**323699 Shancloon Windfarm, County Galway:
Hydrogeological Review**

Client: An Coimisiún Pleanála

Dated: 13th July 2026

Figure 2 Bedrock geology, structure and mapped karst

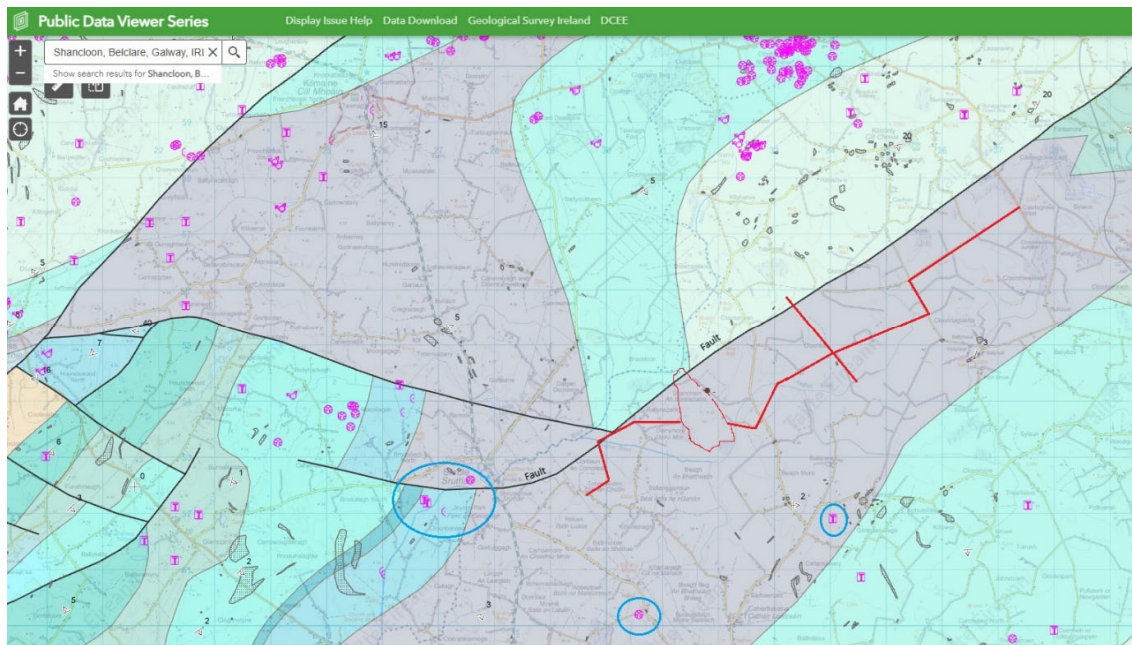
Table 2-3 of Appendix 11.2 presents 32 karst features mapped by GSI within 5km of the Site. Figure 2 below provides a map showing the location of mapped karst features. The red line represents the approximate area of the Site and the blue circles highlight features that may be considered close and downgradient. These features include turloughs. The Black River down stream of the confluence with the Togher River and Shule town should also be considered surface water systems probably connected to the karst limestone aquifer, down gradient of the Site.

Figure 3 Figure 2-1 from Appendix 11.2 of EIAR

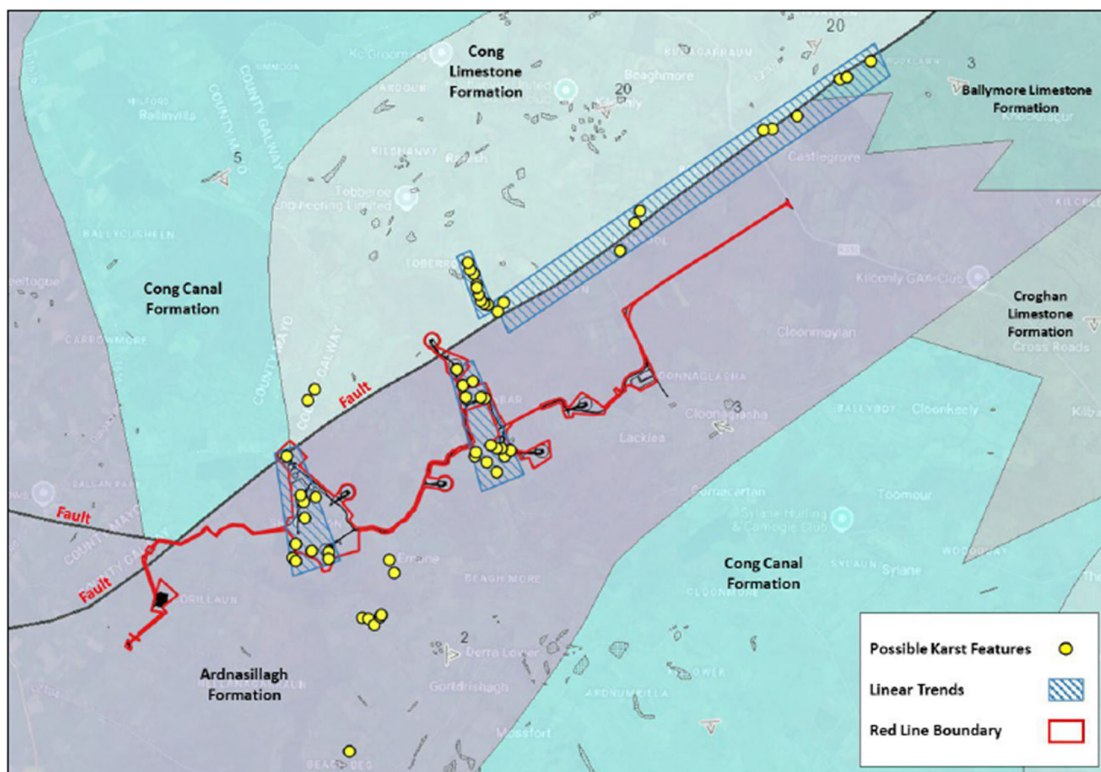
Figure 2-1 of Appendix 11.2 provides a map of the distribution of the karst features that have been identified. It is important to note the linear distribution of the features and the association with the north east trending fault. The north south trending distributions that cross the Site may be associated with unmapped faults or other structural features. It is common in settings where the limestone is impure, that karstification concentrates along structural features. It is also possible that the Ardnasillagh Formation is thin (<20m) and that the north south trends represent connection to underlying pure limestone formations.

Figure 3 below reproduces Figure 2-1 of Appendix 11.2 and adds to and complements Figure 2 above. The two figures demonstrate that karst features link the Site and the wider environment.
